DISCUSSION ON THE LHC PIMs (22/09/2010)

Elias Métral and Francesco Bertinelli

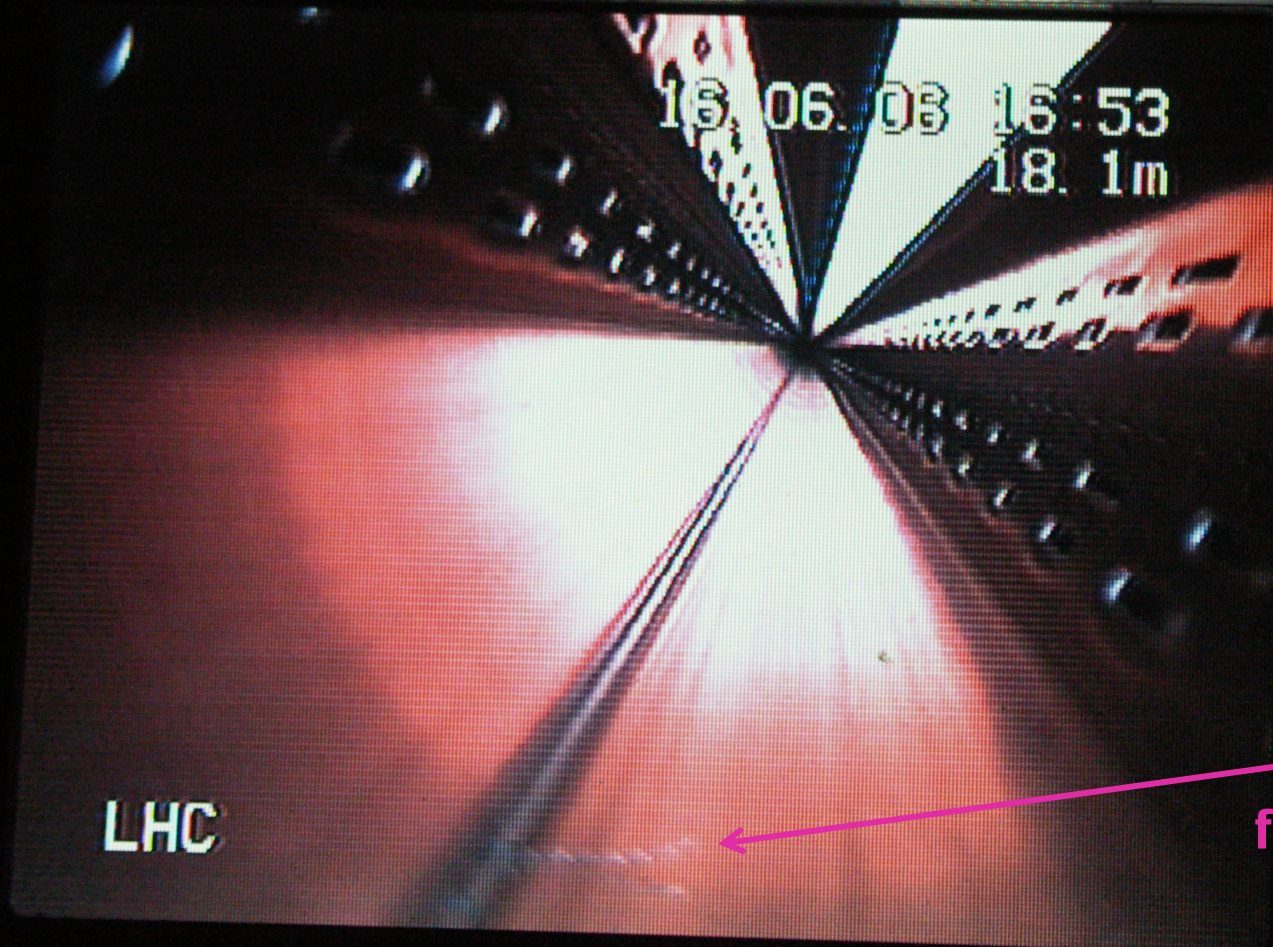
- ◆ **Questions:**
 - **What can/should we do for the RF contacts of the LHC PIMs when the machine will be opened?**
 - **If we see some small plastic ribbons, what do we do? (Most probable question which might arise in the future)**
- ◆ **Answer: Nothing particular to be done => Try and remove what is seen and can be removed...**

RF contacts
(short, fixed => Will be
in fact compressed to
assure the electrical
continuity of the
bellows)

RF fingers
(long, sliding)

Buckling
("flambage") of
some RF fingers

This picture from endoscopy shows a small plastic ribbon
